Z O N I N G
A D J U S T M E N T S
B O A R D
S T A F F R E P O R T

FOR BOARD ACTION
OCTOBER 26, 2023

600 ADDISON STREET

Appeal of Design Review Committee Decision to approve the Coordinated Sign Program #DRCP2023-0002 for exterior building signage of an approved research and development (R&D) campus containing two buildings totaling 470,573 square feet of gross floor area and 943 parking spaces.

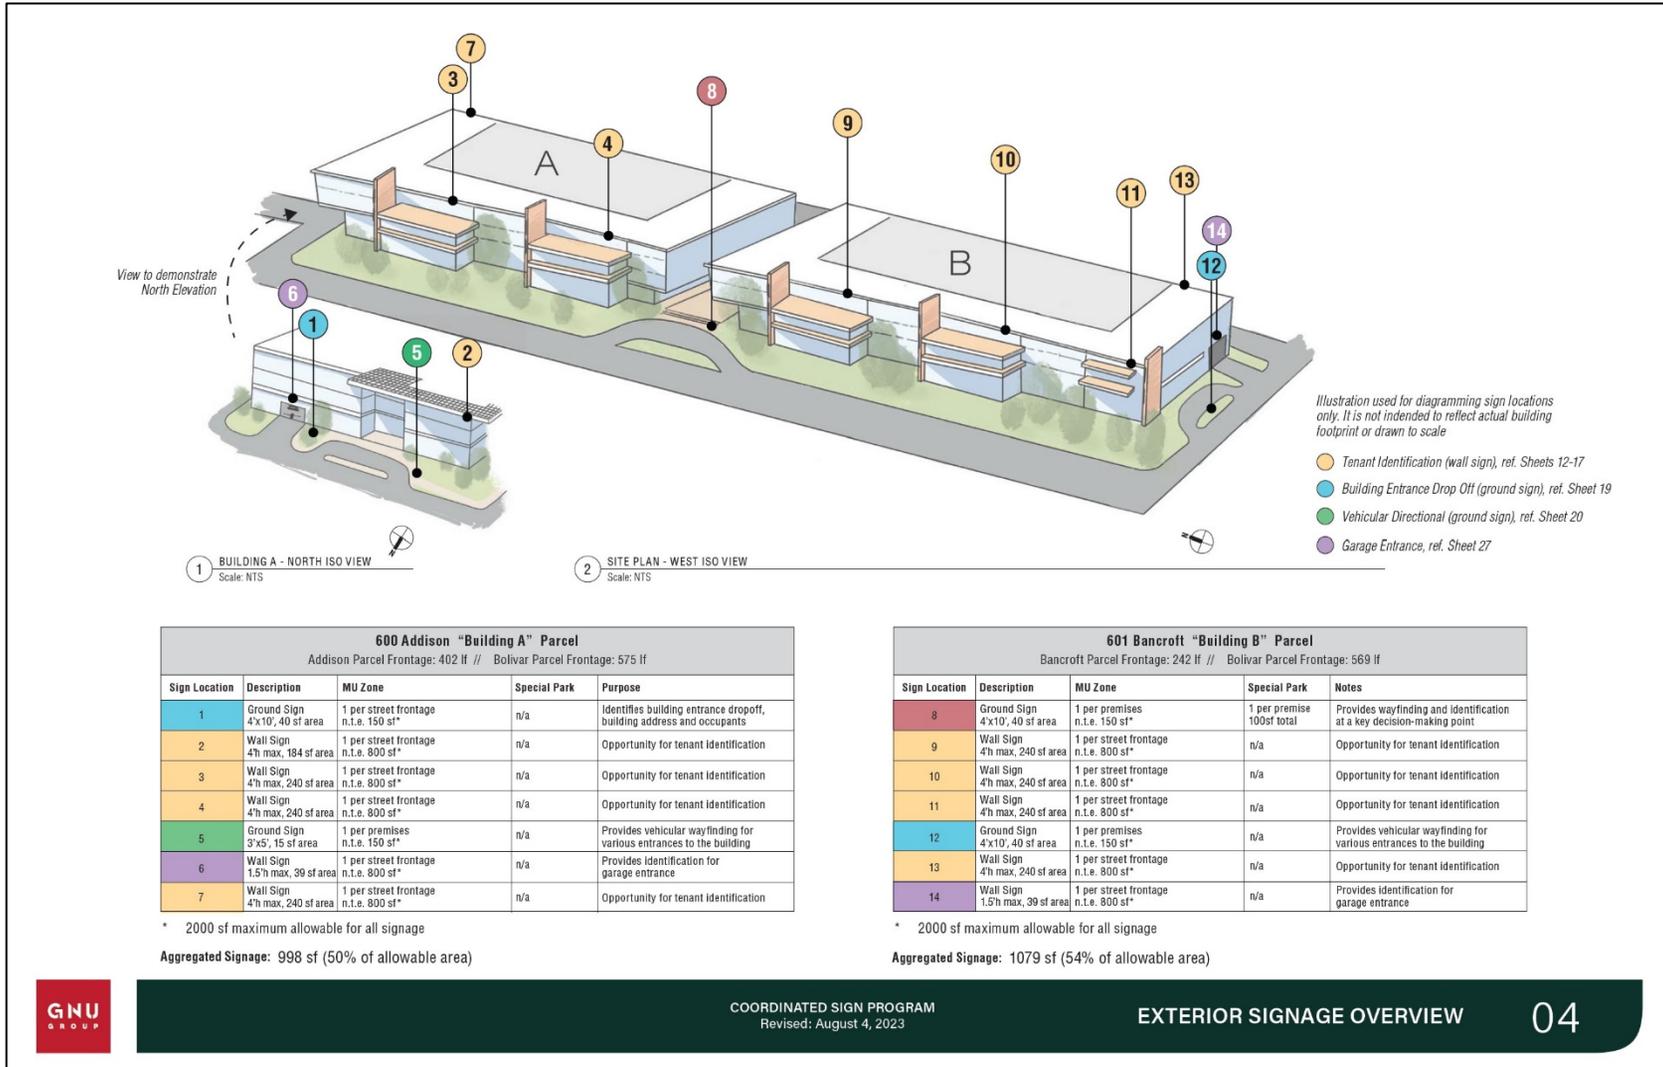
- 3) Because the approved signs will be located both under extended sun shades and above lower building projections (see Figure 1), direct light emanating from them will not be visible from above nor from below out to a distance encompassing the eastern margin of Aquatic Park, thereby having minimal potential for impacting birds that occupy the eastern shoreline of the park.
